**Controller Evaluation of CPDLC
Services Implemented on the Display
System Replacement (DSR)
Workstation:**

**Study 1 -- Initial Assessment of Services
Transitioned From the PVD and Design
Development for Additional Services**

DOT/FAA/CT-TN99/11

FIGURE 1. DSR DATA LINK KEYBOARD

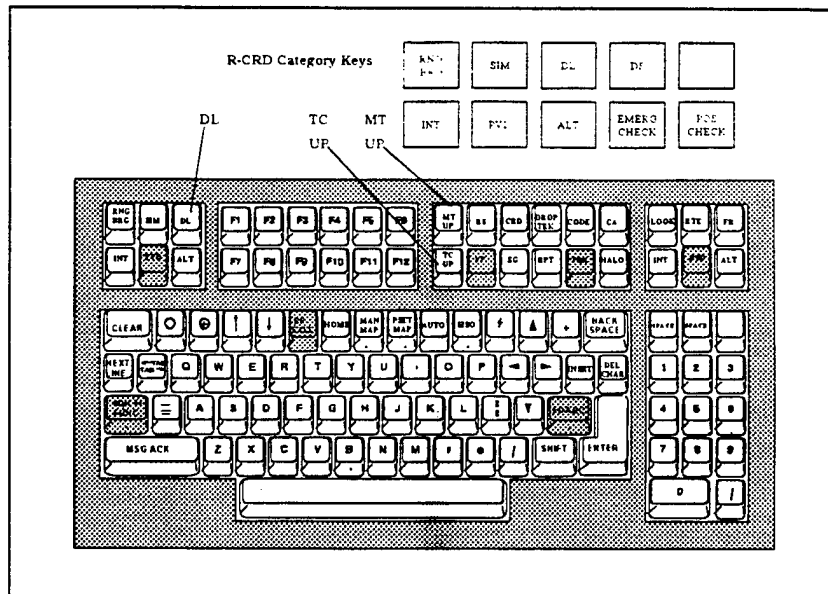
The consensus of the group was that, for CPDLC I, the *MT UP* and *TC UP* keys should be relocated to the far right of the bank of 12 hard-labeled function keys in which they were positioned for testing. The controllers noted that this location was preferable because it would permit rapid access to the keys when making entries on the numeric keypad and when using the routinely employed function keys located in the six-key bank to the right of the keyboard.

A majority of the participants agreed that the Data Link key labels were meaningful and not susceptible to confusion with other key designations. While color coding of the key caps to enhance distinctiveness was discussed during the debriefing, it was noted that two colors had already been added to the DSR key caps, and that proliferation of the practice may diminish the value of color as an aid to key identification.
